## STAFF REPORT

Community Planning and Preservation Commission  
Certificate of Appropriateness Request

CITY FILE NO.: 20-90200109

Review of a Certificate of Appropriateness for construction of a new garage at 2151 4<sup>th</sup> Ave N, a contributing resource to Southeast Kenwood Historic District.

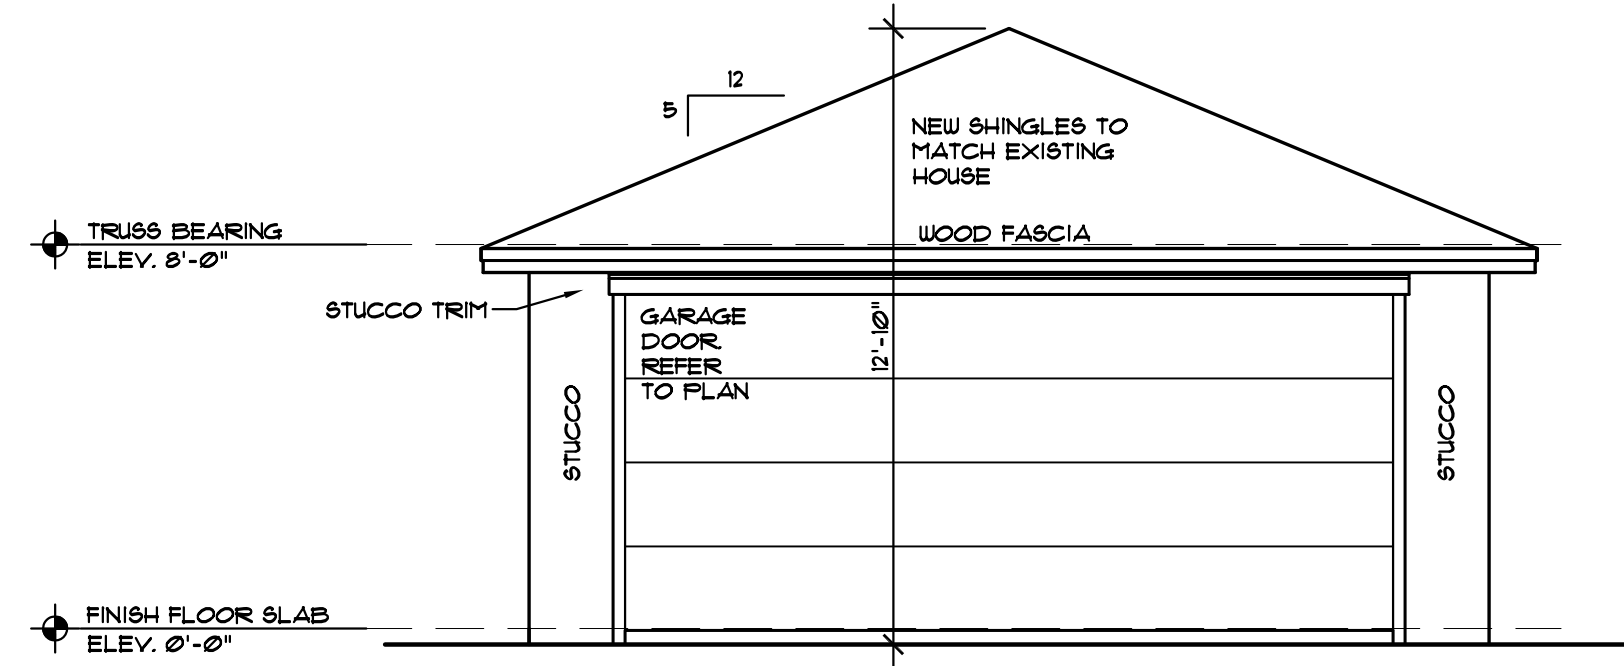
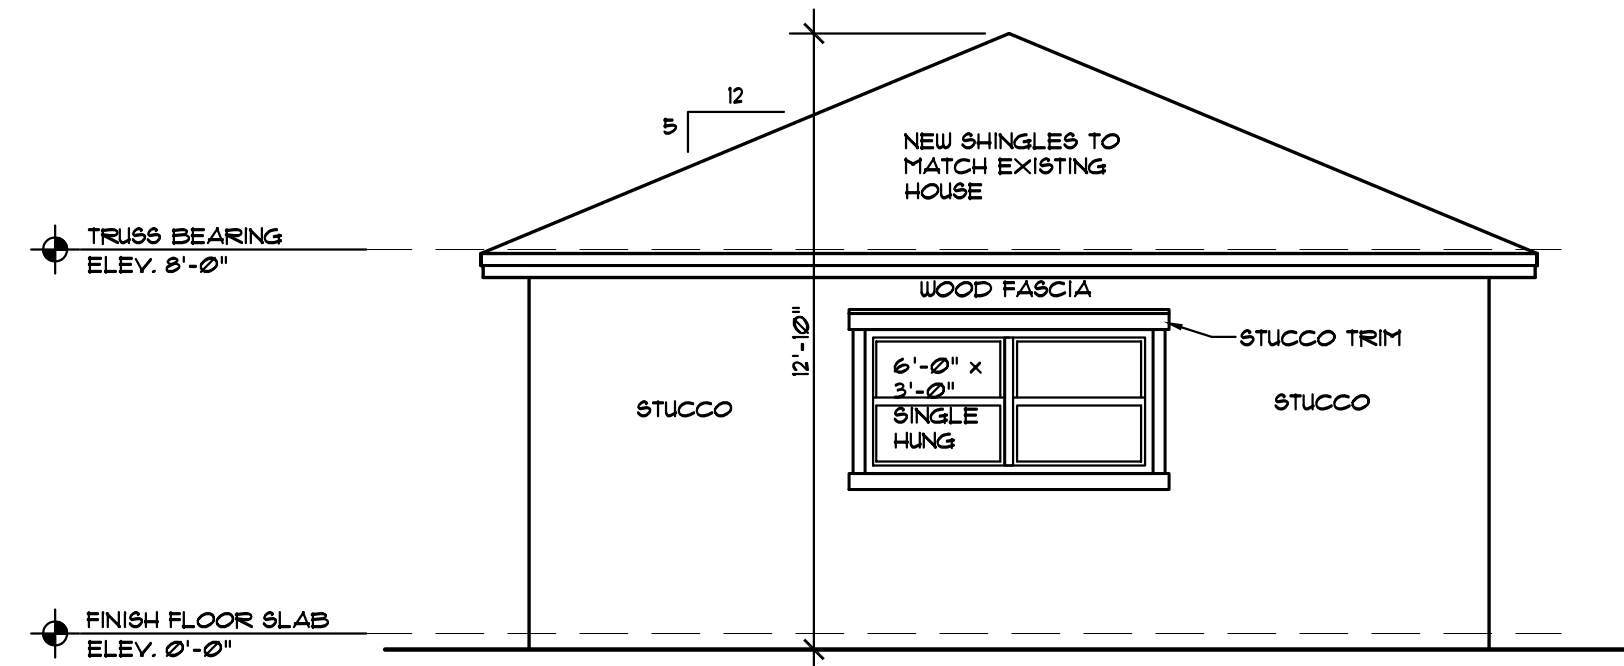
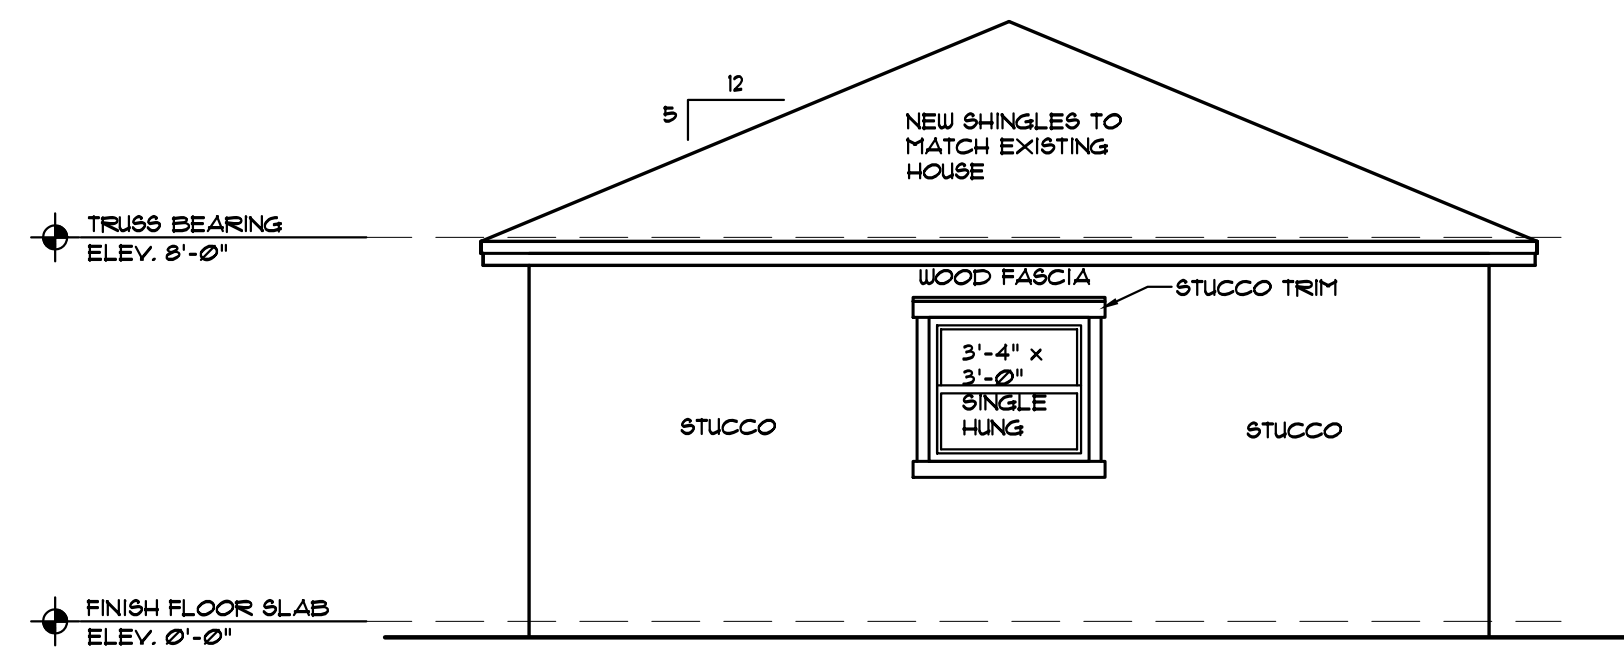
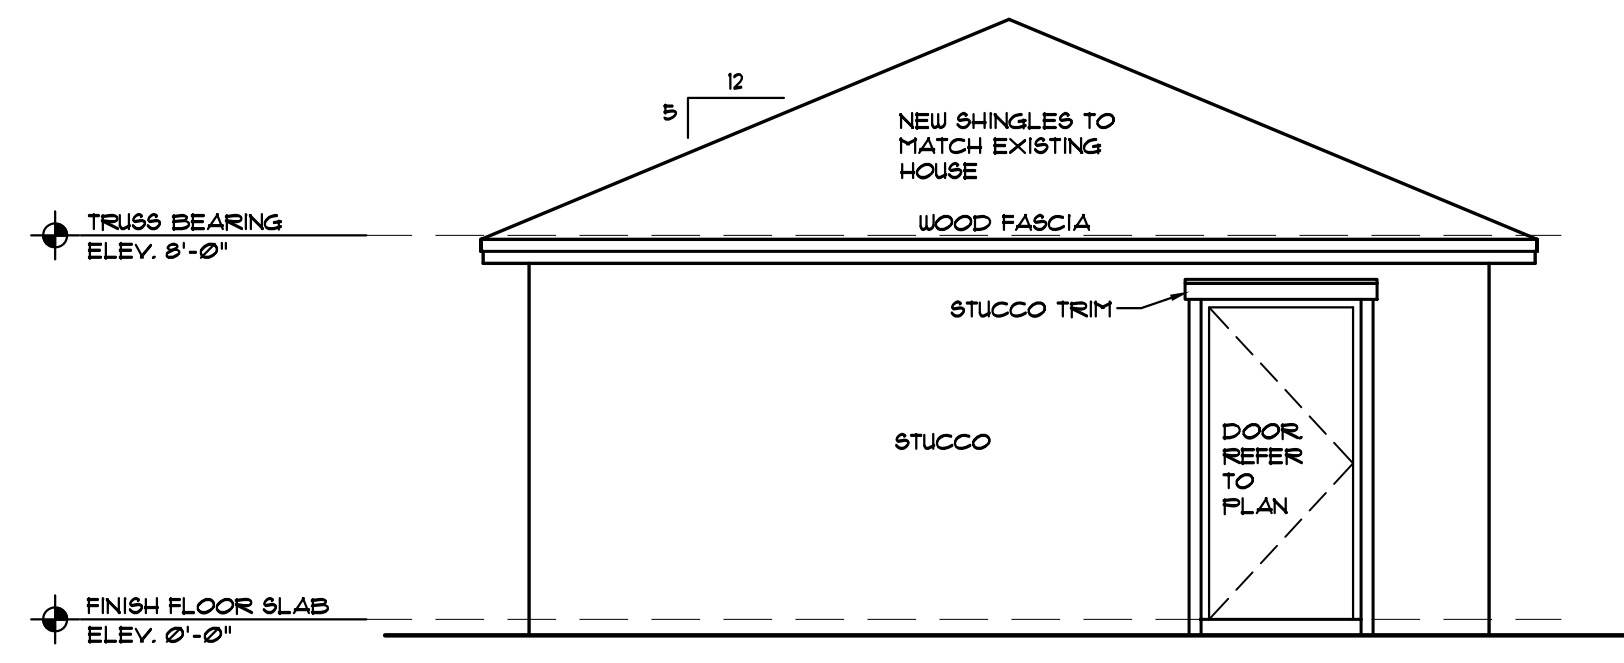
**Consistent** The proposed garage will have a roof peak of approximately 12'. This is generally consistent with historic one-story accessory buildings in the subject district.

**Consistent** The proposed garage will be 20' wide. Typical historic detached single-car garages tend to be approximately 10' to 12' wide, and two-car detached garages and garage apartments are commonly 18' to 24' wide. The alleyway which the garage will be facing has numerous extant garages that are 20+ feet wide, so staff finds the width to be appropriate. The proposed height of 12 feet will be compatible with the surrounding detached garages.

**Consistent** The proposal includes multiple windows, which will be interior facing. The applicant proposes simple one-over-one windows that look to be proportionate to the main building.

**Consistent** Detached garages typically have fairly utilitarian, often sparse, fenestration patterns. The proposed garage is in keeping with the district in regarding fenestration patterns on detached garages.

**Consistent** The proposed roof has a 5:12 hipped roof. This is consistent with comparable contributing resources.

**Consistent** The utilitarian nature of many of the accessory buildings (particularly garages) in the subject district results in comparably less fenestrations than primary residences. Staff finds the proposed massing and rhythm of the accessory building to be generally in keeping with that found in the subject district.

1. Windows will be installed to be setback within the wall plane and feature a reveal of at least two inches.
2. All other necessary permits shall be obtained. Any additional work shall be presented to staff for determination of the necessity of additional COA approval.
3. This approval will be valid for 24 months beginning on the date of revocation of the local Emergency Declaration.
